NEW MEXICO OIL CONSERVATION DIVISION
 - Engineering Bureau -
 1220 South St. Francis Drive, Santa Fe, NM 87505

APPLICATION FOR AUTHORIZATION TO INJECT

WELL NAME & NUMBER: Saffron AON State #1 30-025-32108

Re: Cimarex Energy Co. C-108 application on Saffron AON State #1, 30-025-32108, Sec. 2,
T23S-R32E Lea Co.

Proposed Configuration for Saffron AON State #1 SWD Conversion

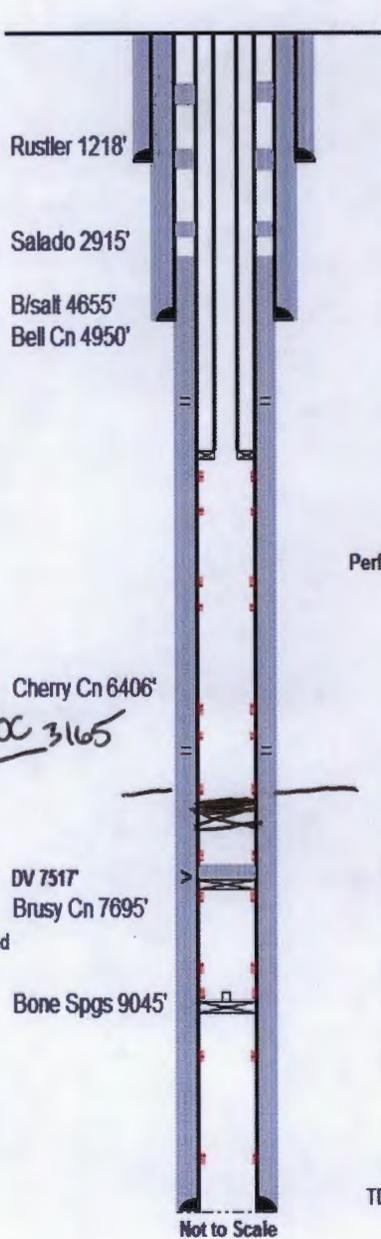
Perfs 5468'-7424' OA 08/05/13 e-mail

Noted in Yates diagram & accepted by OED - no CBL in log file

Change In Design Bottom to 7,070 CIBP at 7390 + 35' Amt

OXY USA, Inc., (OXY Permian Primary Development) has advised Cimarex through the undersigned of it's concern that the lowermost perforations proposed in the re-entry may be in or close to a zone planned for lateral drilling in the near future. Based upon OXY's request Cimarex wishes to revise upward the bottom perforation from 7,424' to 7,070'.

The plan is now to re-enter and set a CIBP in the 5-1/2" approximately 7390' +35' cmt, and tagged. The lowest perforation will be the presently existing shot at 7,070'.

Final Order Make CIBP within 260' of lowest Perf

Permit Conditions: Issues: CIBP proposed for 7390'; distance: 7390' - 7070' = 320'; No CBL on

Add Permit Cond: Move CIBP to within 200ft of deepest perf; CBL for 5 1/2 in casing file
